RE: SES Solar One Project
Applicant's Responses to the CEC Memo Regarding Transmission Line Upgrades

SES Solar One
Response to CEC Memorandum
Docketed 12/8/2009
08-AFC-13

TECHNICAL AREA: TRANSMISSION LINE UPGRADES

Vegetation and Special-Status Species Maps of Proposed Transmission Line Corridor

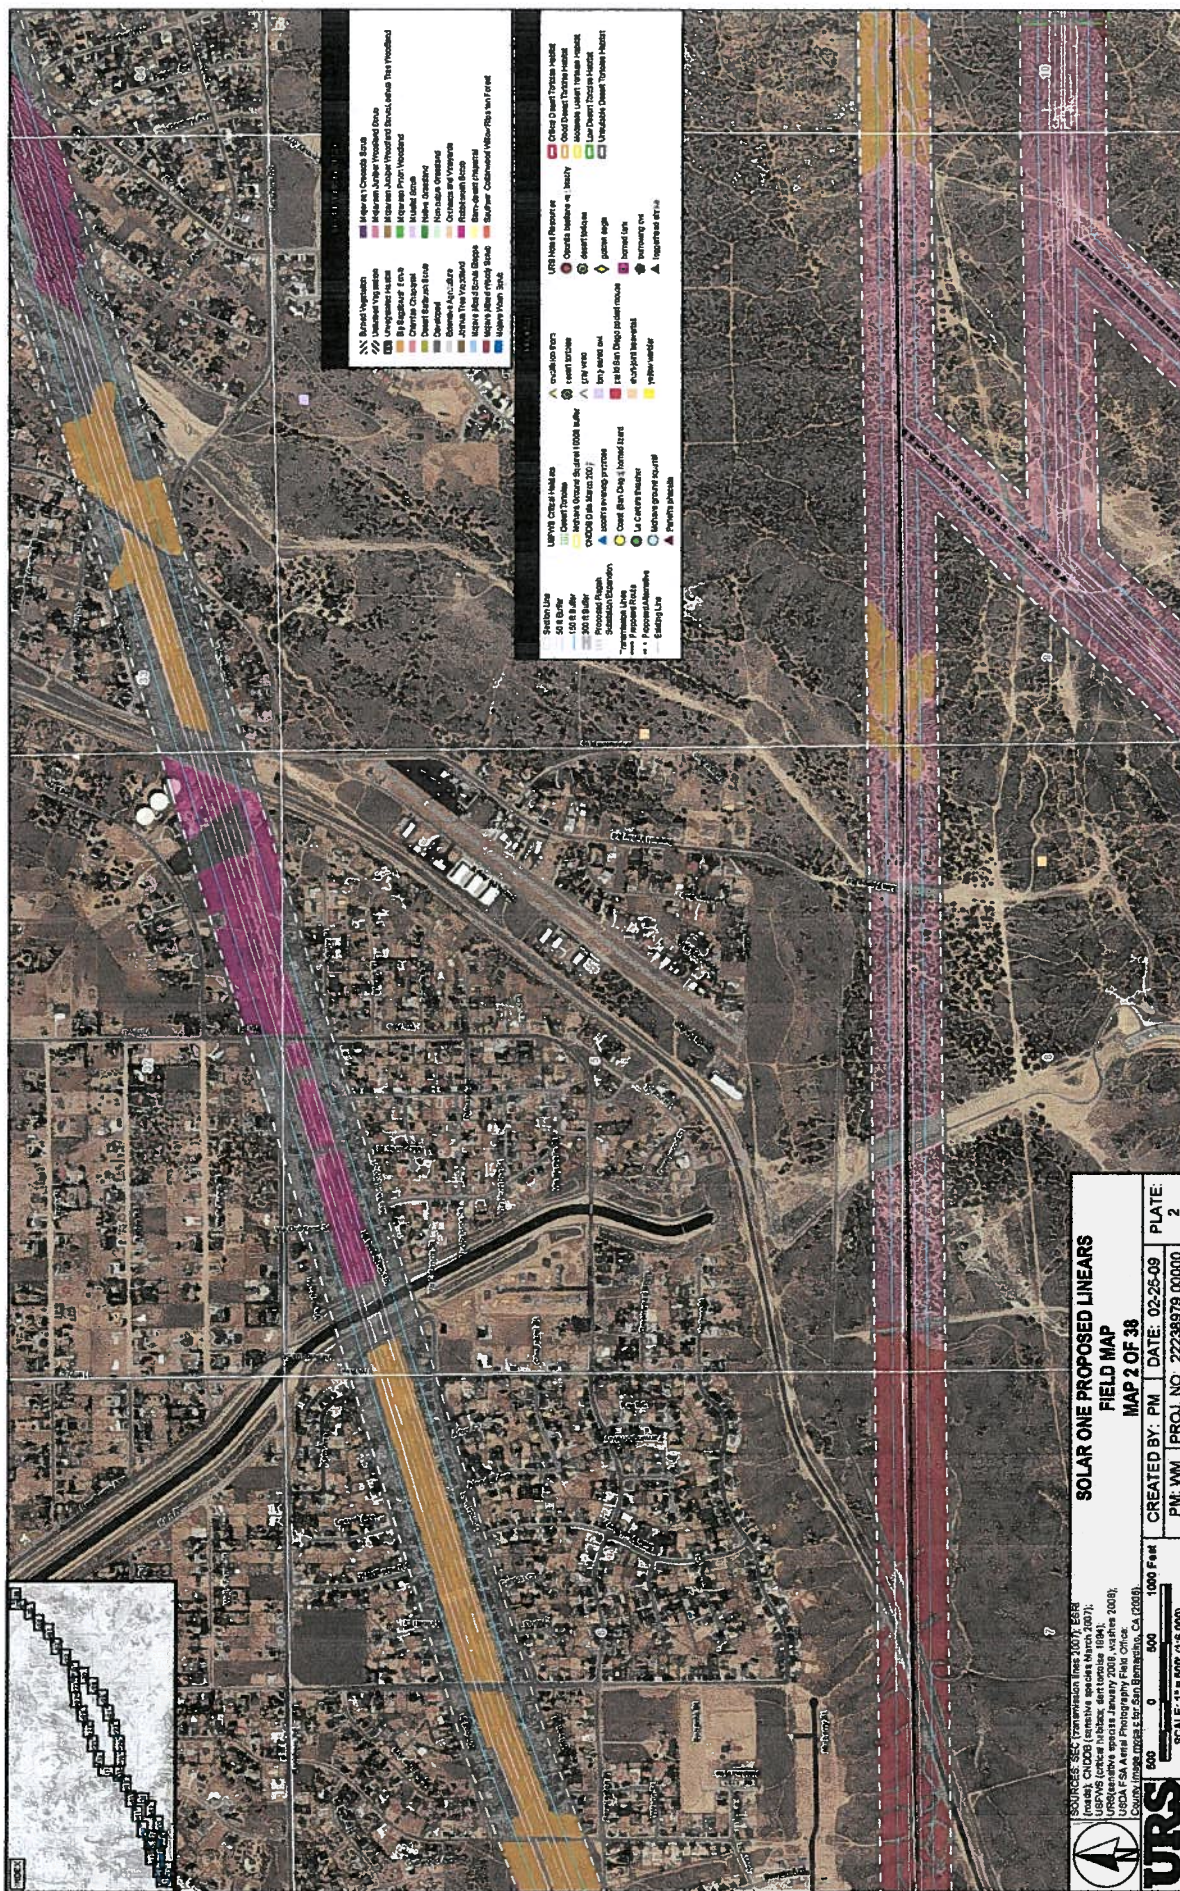
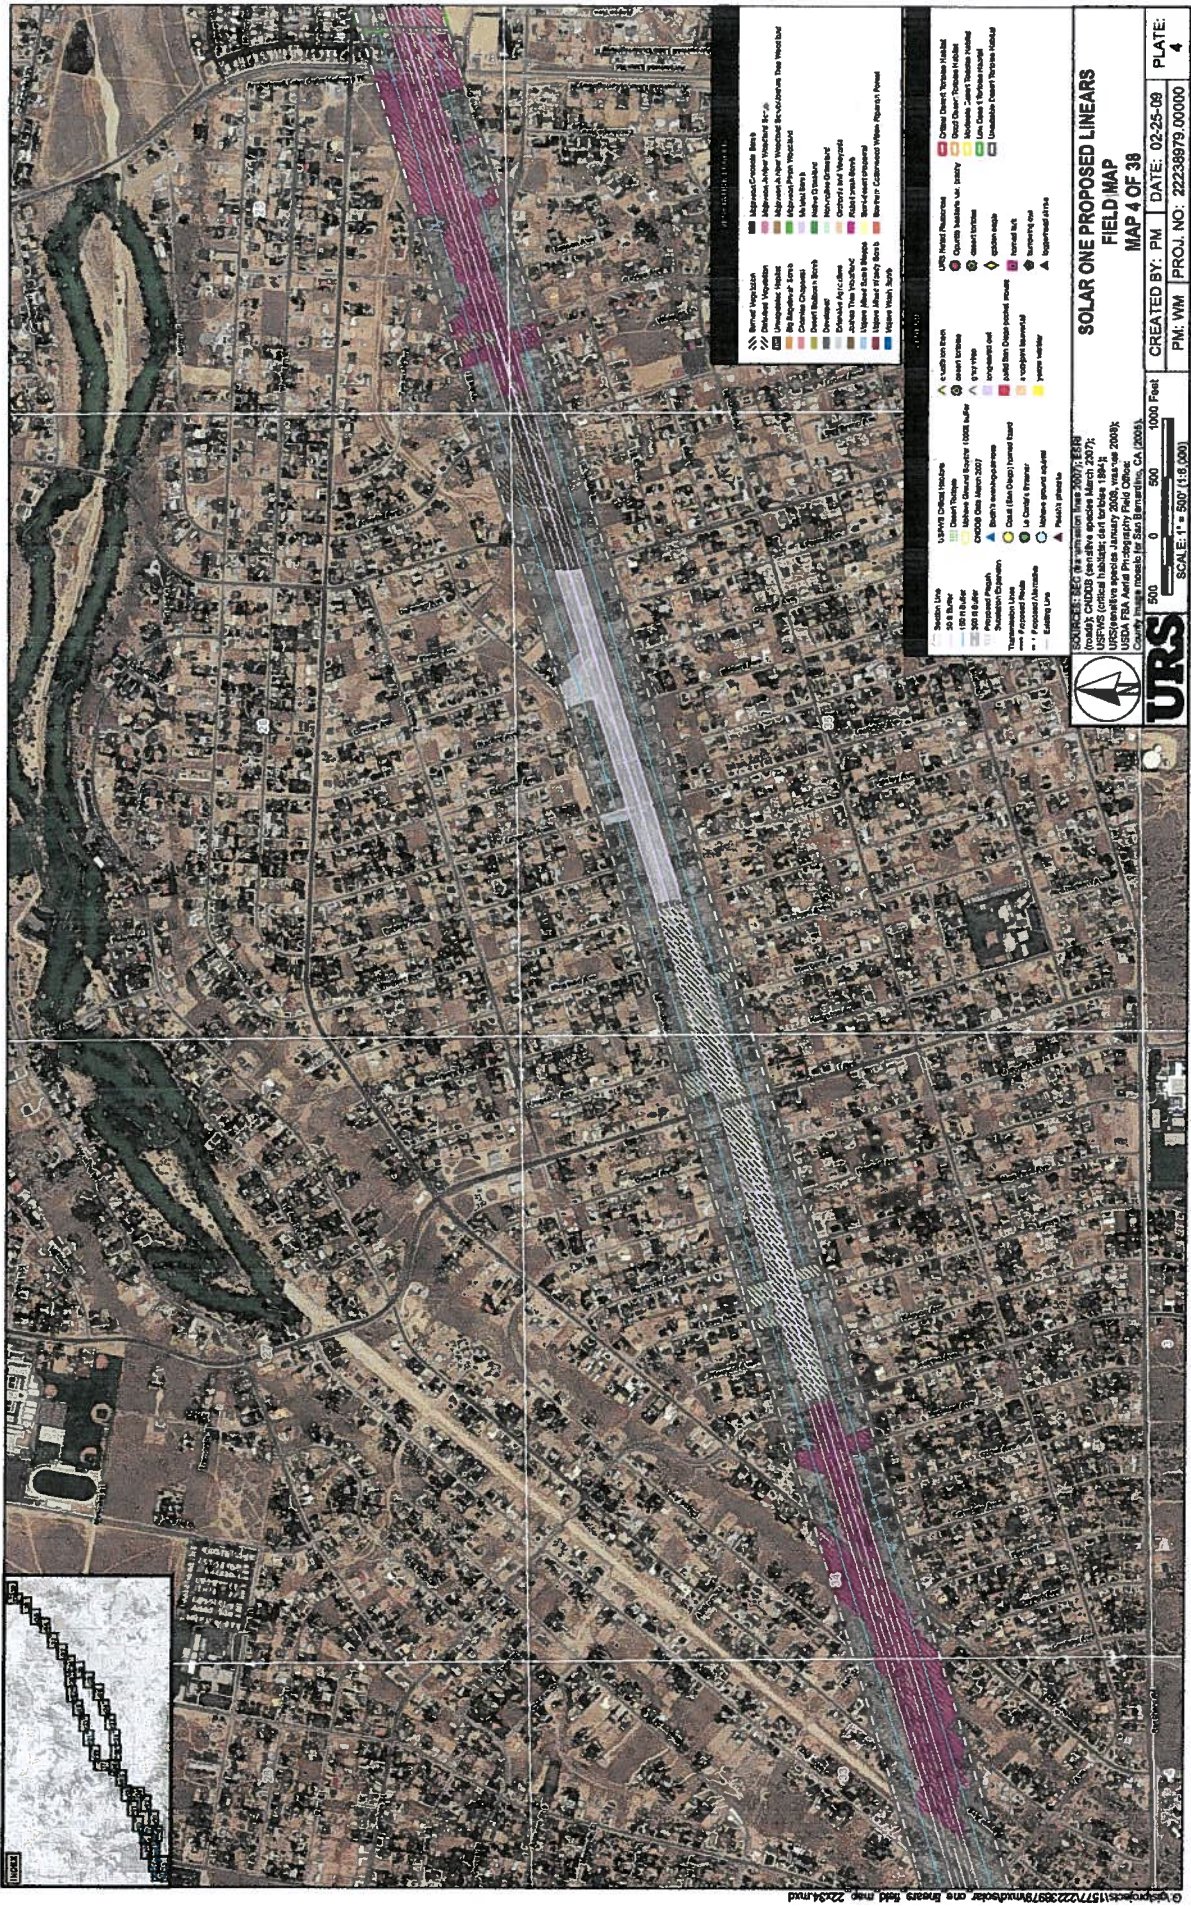
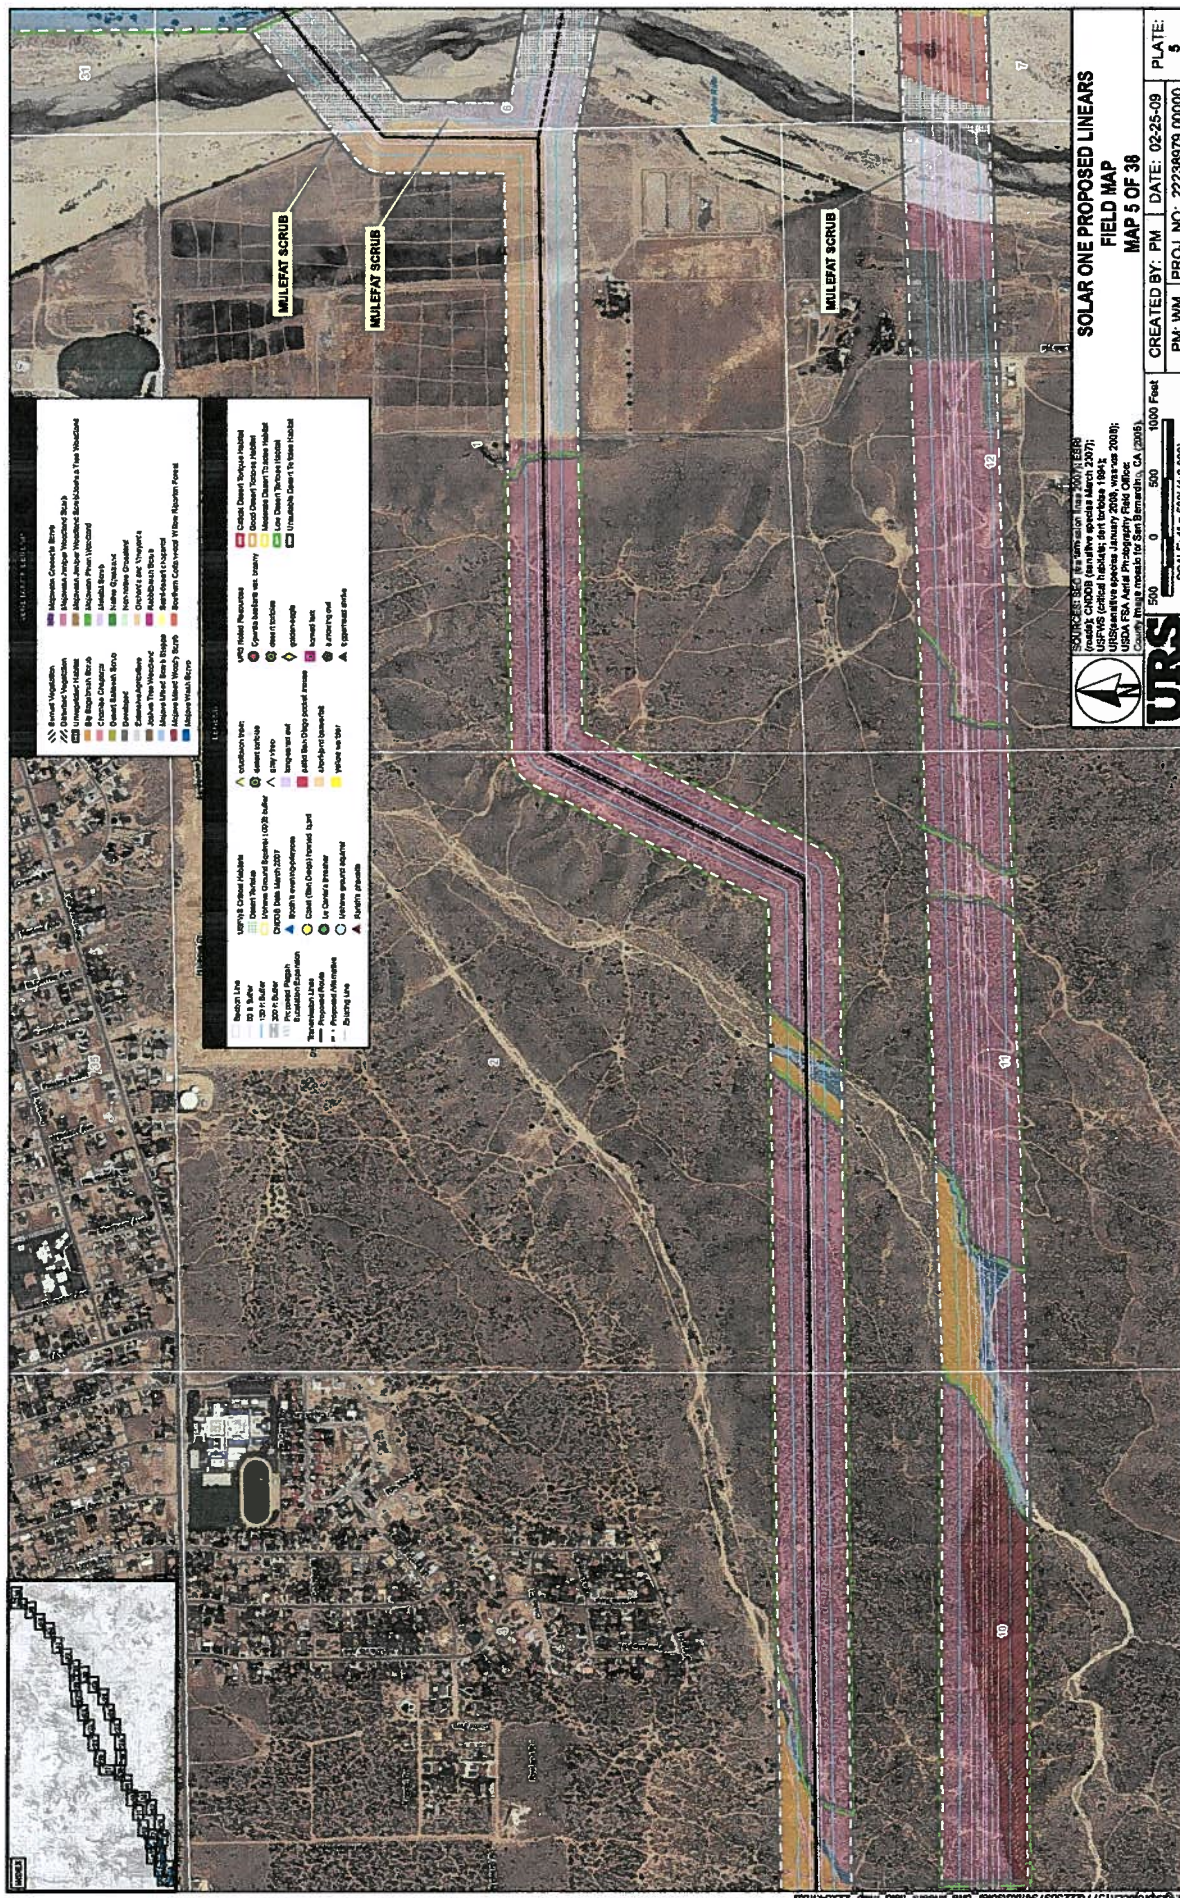
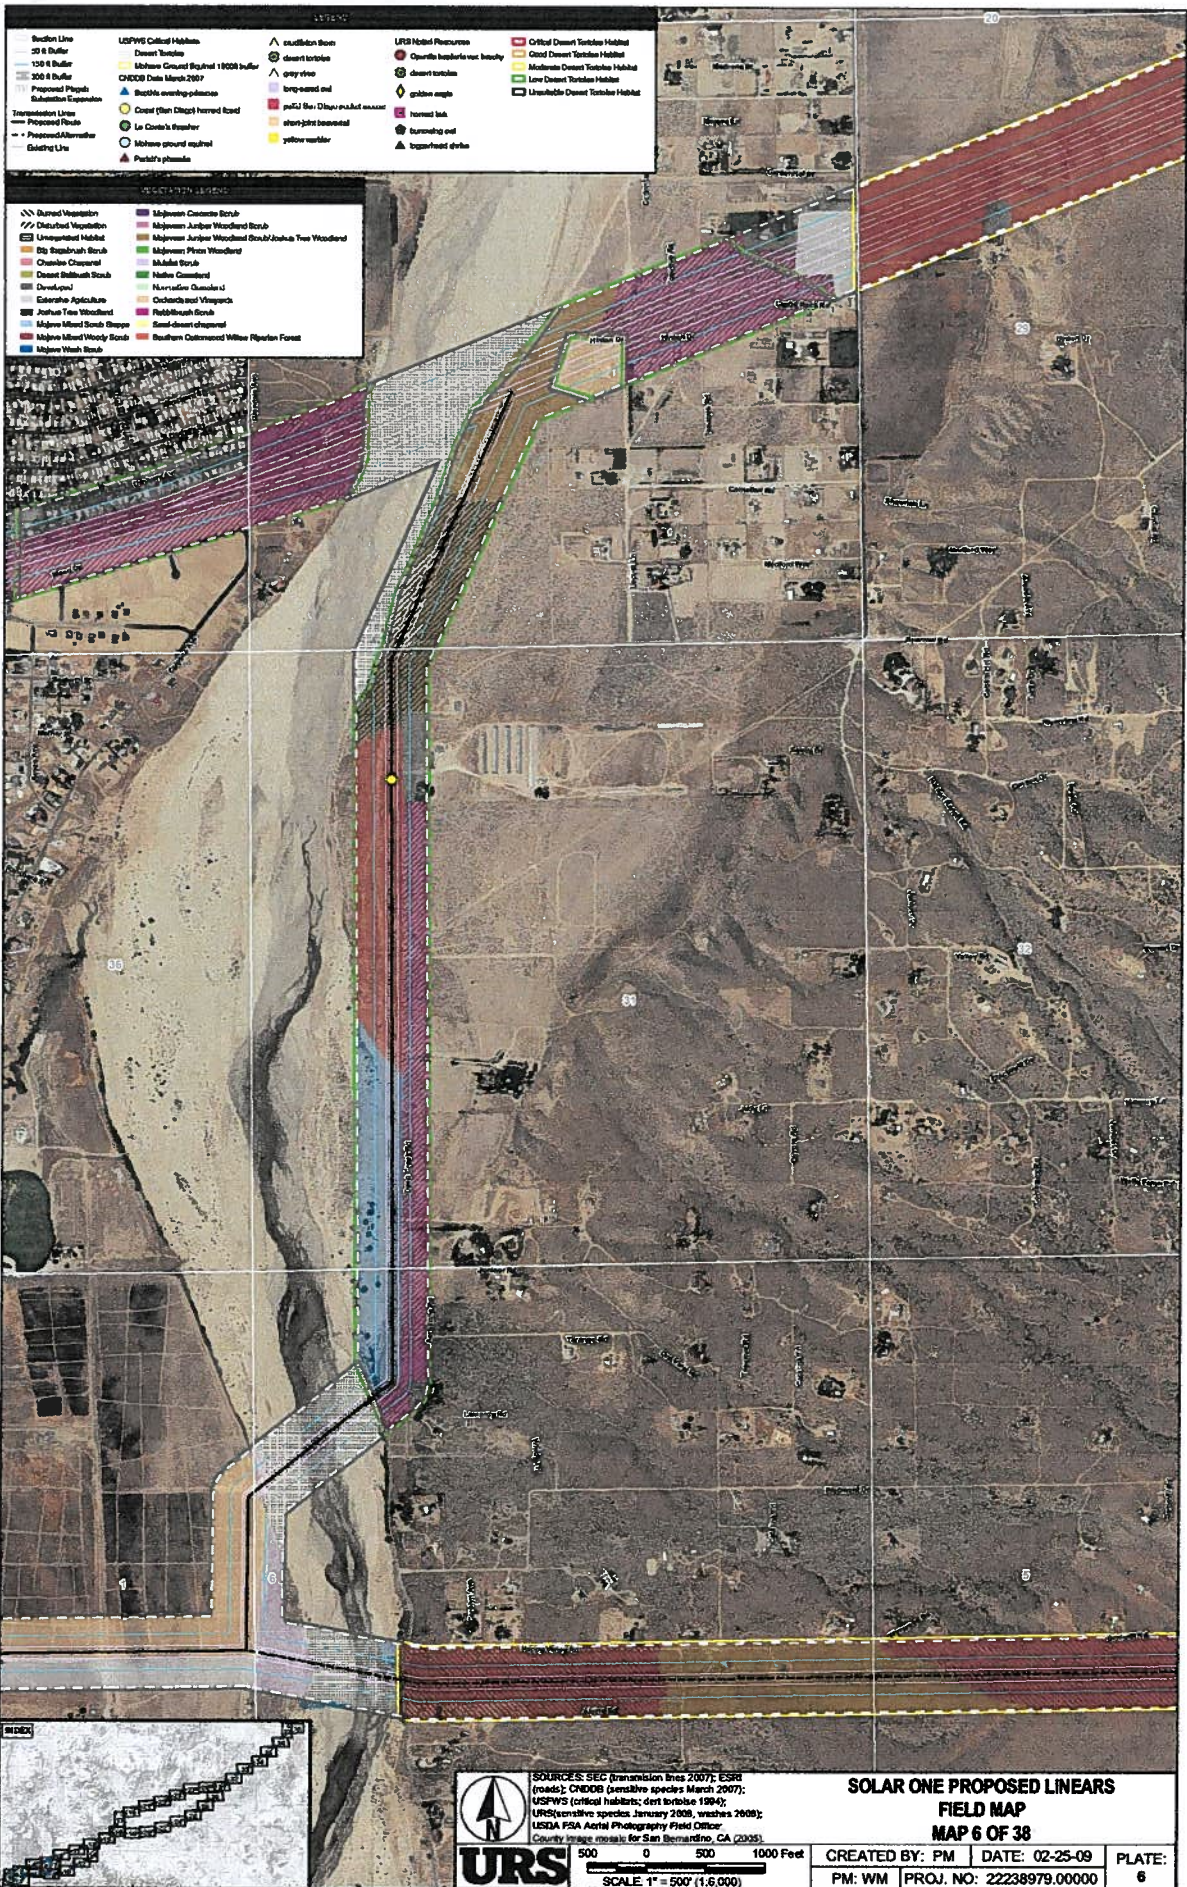
Item 1: For the areas affected by the transmission line upgrades, provide information related to special-status species surveys for both plants and animals done when the organisms are identifiable (multiple trips out, especially for plants)

Response: Maps of vegetation types and special-status species locations along the transmission line are provided as attachment TRANS-1 provided behind this response. The abundance and location of each special-status species that was detected during surveys are provided below as Table 1. The survey dates and personnel conducting each survey are provided in Table 2.
